# Access Compliance Report

## Public Rights-of-Way

### (Curb Ramps)

Intersection ID: 29469	Main Street: BROOKCHASE LN	Cross Street: DOWNING ST	Location:	N
ADA ID: AA59357879C1	Ramp Type: PerpDiag	Initial Pass/Fail: Fail	Overall Compliance: No	Severity Score: 37.5
Codes/Mitigation Info/Possible Solution		Field Measurements/Component Compliance

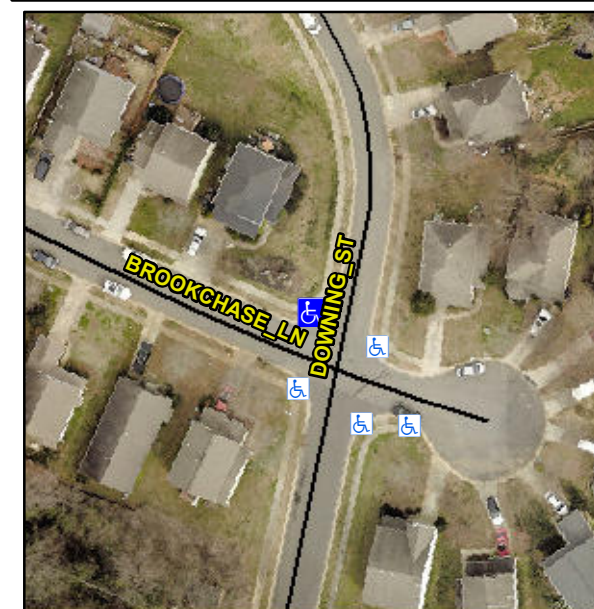
**Not Found, R304.2.2, R304.5.3**

Compliance	Description	Data	Compliance	Description	Data
N/A	Ramp Length (in)	46.5	No	Ramp Slope (%)	8.8
Yes	Ramp Width (in)	48.0	No	Ramp XSlope (%)	9.0
N/A	Flare Type LT	N/A	N/A	Flare Type RT	N/A
N/A	Flare Slope LT (%)	N/A	N/A	Flare Slope RT (%)	N/A
N/A	Flare Traversable LT?	N/A	N/A	Flare Traversable RT?	N/A
N/A	Landing Length (in)	N/A	N/A	DWS Provided?	N/A
N/A	Landing Width (in)	N/A	N/A	DWS Contrast?	N/A
N/A	Landing Slope (%)	N/A	N/A	DWS Length (in)	N/A
N/A	Landing X Slope (%)	N/A	N/A	DWS Full Width?	N/A
N/A	Landing Curb? (Y/N)	N/A	N/A	DWS Offset (in)	N/A
N/A	Shared Landing?	N/A			
N/A	Gutter Ponding?	N/A	N/A	Gutter Slope (%)	N/A
N/A	Gutter Lip Ht (in)	N/A	N/A	Gutter X Slope (%)	N/A
N/A	Painted X Walk1?	No	N/A	Painted X Walk2?	No
	X Walk 1 Direction	To SW		X Walk 2 Direction	To SE
N/A	X Walk 1 Width (in)	N/A	N/A	X Walk 2 Width (in)	N/A
	X Walk 1 Slope (%)	3.5		X Walk 2 Slope (%)	4.7
	X Walk 1 X Slope (%)	6.7		X Walk 2 X Slope (%)	4.1

**Remove & Replace Curb Ramp With Two New Directional Ramps or Equivalent.**
